Subject: Response to Request for Additional Information (RAI) Letter No. 8 –
Exelon Early Site Permit (ESP) Application for the Clinton ESP Site
(TAC No. MC1122)

Re: Letter, U.S. Nuclear Regulatory Commission (N. V. Gilles) to Exelon
Generation Company, LLC, (M. Kray), dated July 27, 2004, Request for
Additional Information Letter No. 8 – Exelon Early Site Permit
Application for the Clinton ESP Site (TAC No. MC1122)

Enclosed, as requested in the referenced letter, are responses to the requests for additional information (RAIs) associated with the geography, demography, and radiological consequences of accidents portions of the Exelon Generation Company, LLC (EGC) ESP application.

Figure 2.1-8
ESP Exclusion Area Boundary and
Low Population Zone

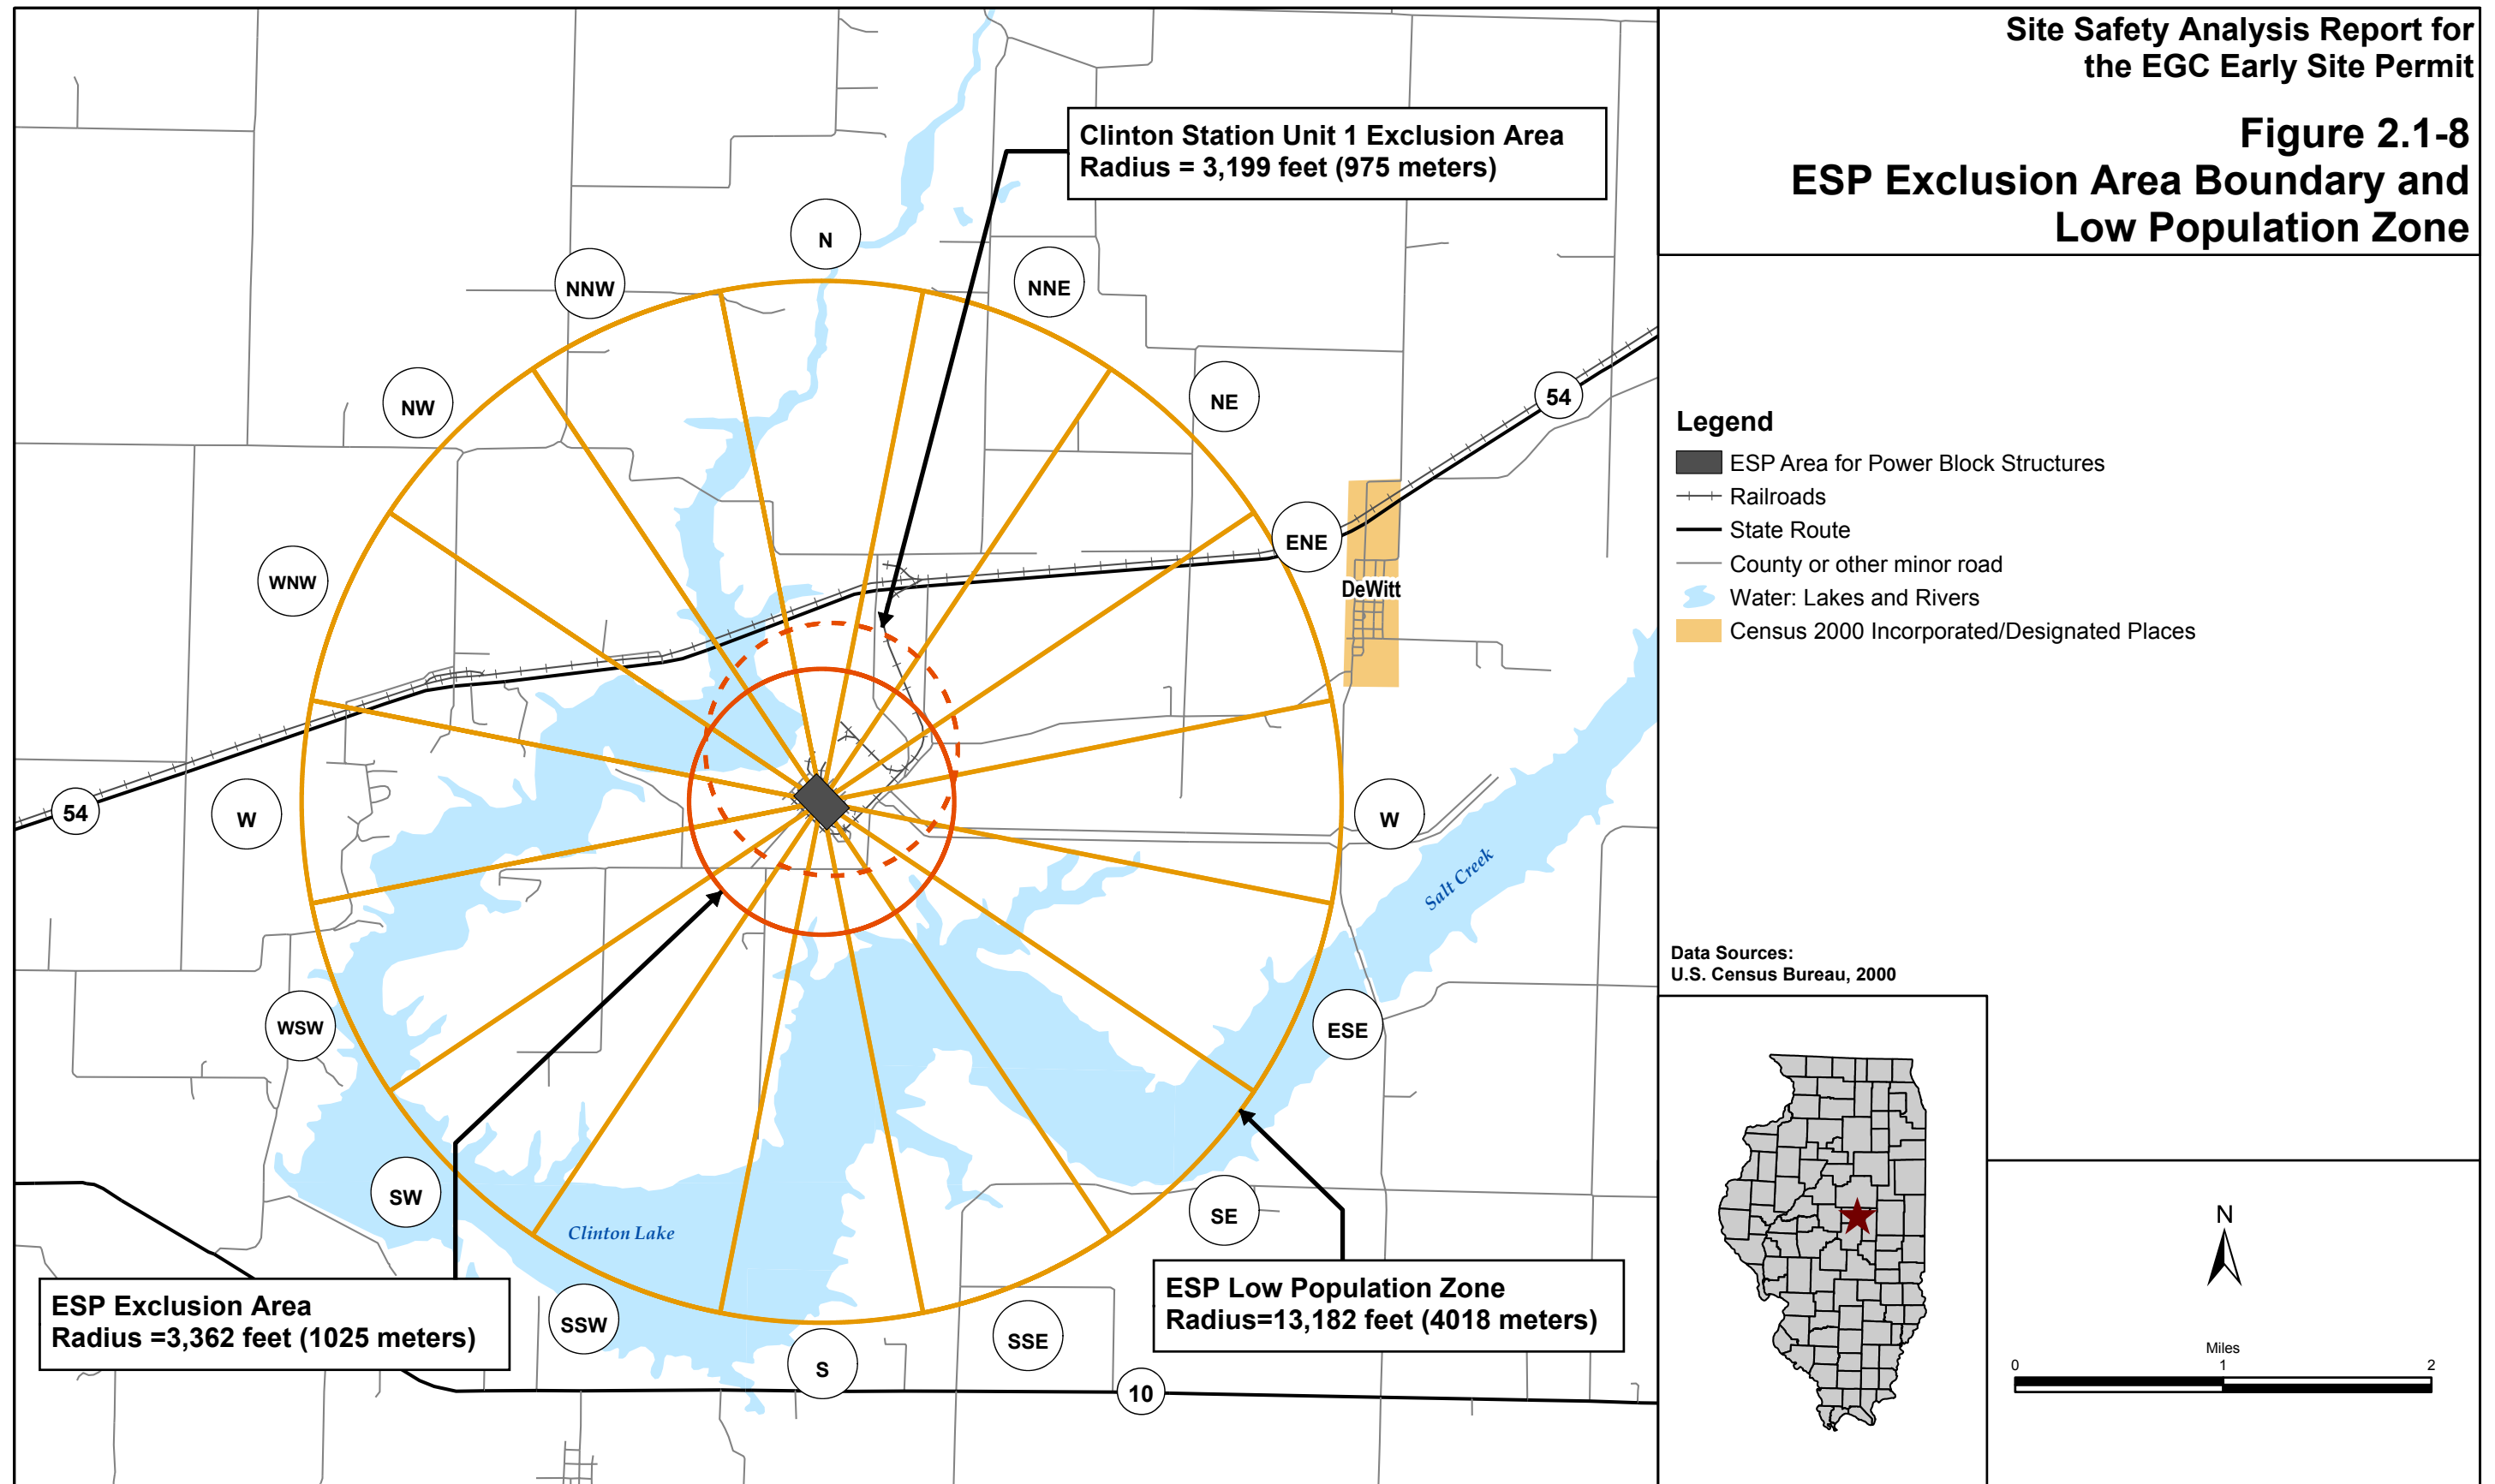
SSAR Figure 1.2-3 shows the proposed ESP exclusion area boundary (EAB) and low population zone (LPZ), and the distances to the EAB and LPZ by sector. Please provide an expanded and legible figure to clearly show the proposed EAB and LPZ as well as existing Clinton Power Station EAB. Please provide the direction distances to the EABs and LPZ by sector. Please state the distance from the proposed ESP site to the nearest EAB line for the proposed ESP site, including its direction and distance.

SSAR, Chapter 2, Figure 2.1-8 (as attached to this RAI response) has been provided to more clearly show the proposed ESP exclusion area boundary (EAB) and low population zone (LPZ) as well as the existing Clinton Power Station EAB. The ESP EAB is based on maintaining a minimum distance of 0.5 miles (805 meters) from any point on the ESP Plot Plan for locating the Power Block Structures. This resulted in an exclusion area with a radius of 1025 meters for the EGC ESP site. The LPZ was maintained at a distance of 2.5 miles (4018 meters) since this area contains residents whose total population and density are such that there is reasonable probability of providing appropriate protective measures based on both the Clinton Station Emergency Plan (EP) and EGC ESP major features EP documentation.

Figure 2.1-8 shows the EGC ESP Site Exclusion Area Boundary (EAB), and Low Population Zone (LPZ), as defined in 10 CFR 100. The exclusion area is entirely within the property boundary (Figure 1.2-3) and is the area encompassed by a radius of 1,025 m (3,362 ft) from the center of the ESP Facility footprint area for locating power block structures. The low population zone is the area encompassed by a circle of 4,018 m (2.5 mi) radius.

The exclusion area for the EGC ESP Site meets the requirements of 10 CFR 100 as demonstrated in Section 3.3. The boundary line of the EGC ESP Site exclusion area is shown in Figure 2.1-8. The EGC ESP Site overlaps the CPS Facility exclusion area; however, the two are not concentric.

Revise SSAR, Chapter 2, Section 2.1, to add new Figure 2.1-8 as provided in the attachment to this RAI response.
